FNSB ADMINISTRATIVE HEARING
NOVEMBER 22, 2017

SD012-18
WIKE SUBDIVISION

SD012-18 Wike Subdivision

WIKI SUBDIVISION

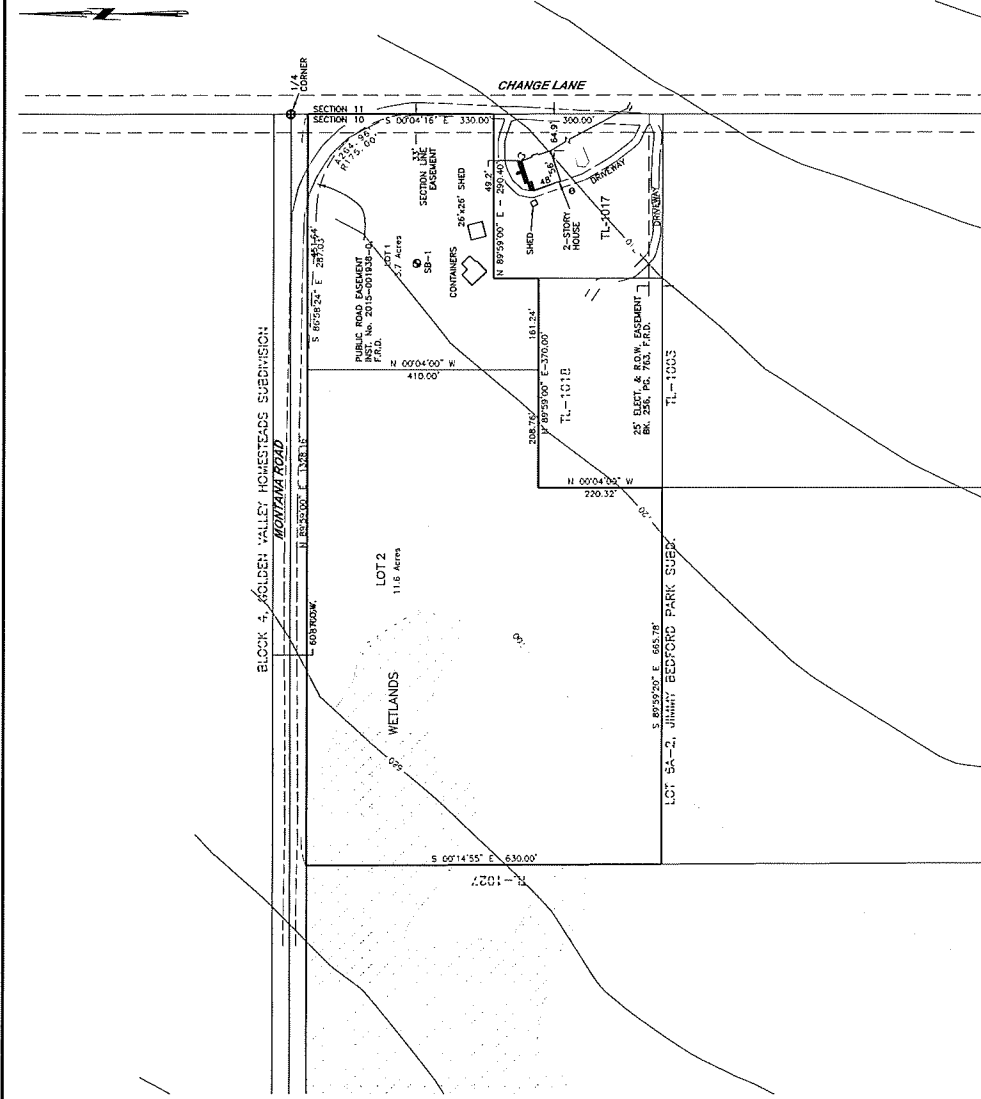
Addressing: Cabin on proposed lot 2 needs its own address. Please have property owner or representative submit a site address request.

- Provide contours at no greater than 20' intervals.
- Show wetlands on plat, as it may be important for installing a driveway; also include the wetlands note.
- Road service area: requires the driveway permit note.
- Note on storm water: "This subdivision has highly erodible soils: disturbance of one acre or more on any single lot may require a Storm Water from ADEC"
- Recommend 18" driveway culverts in this area."

On the preliminary plat, there are no existing structures shown on Lot 2; however, there are existing "containers" and a "26 X 26 shed" on the proposed Lot 1. The existing structures on Lot 1 do not appear to meet the current setback requirement and are not allowed as accessory uses in absence of a primary use. I understand that these zoning violations do not impact the Title 17 platting process. My goal is to inform the applicant and the property owner about these existing violations.

I also want to inform the applicant and the property owner about the "front lot lines" created by the "public road easement inst. # 2015-001938-0, FRD" and the "33' Section line easement" referenced in this preliminary plat. These "front lot lines" would have front-yard setback requirements of 35 feet for any future structures in the RE-2 zone."

"...because this subdivision is in a road service area it will require a note about obtaining a driveway permit. Along those same lines, any driveway for lot 1 cannot intersect on the curve connecting Change Lane and Montana Road, it must come in at a 90 degree angle and intersect on a straight section of road, unless otherwise infeasible."

A Driveway Permit from Rural Services shall be required prior to the construction of any new access or the improvement to any existing access onto Change Lane or Montana Road.

Access onto the horizontal curve portion of the road connecting Change Lane and Montana Road shall require the submission of an engineering study addressing safety concerns as part of the Driveway Permit application."

- A) GVEA requests review of the final plat prior to approval by the FNSB;
- B) GVEA asks that all easements of record be shown on the final plat; and
- C) GVEA requests the 30-foot easement, as described in the attached Right-of-Way Easement, Recorded at [Book] 720 Page 0365 in the Fairbanks Recording District, be depicted on the Wike Subdivision plat."

1. GVEA, Golden Valley RSA and Chena Goldstream FSA shall be given a maximum of 30 calendar days to review and comment on the final plat.
2. All easements of record shall be shown on the final plat.

3. A note shall be added to the final plat that states "This subdivision has highly erodible soils: disturbance of one acre or more on any single lot may require a Storm Water from ADEC."

4. A note shall be added to the final plat that states "Any new access, or the modification of an existing access, within the Montana Road or Change Lane rights-of-way will require an approved FNSB Driveway Permit."

5. A note shall be added to the final plat that states "Portions of this subdivision may contain wetlands. If development plans entail the discharge or placement of dredged and/or fill material into these wetlands, issuance of an individual Department of the Army permit may be required pursuant to section 404 of the Clean Water Act prior to initiating work."

6. A note shall be added to the plat that states "Direct lot access onto the curved portion of the Change Lane and Montana Road rights-of-way is prohibited."
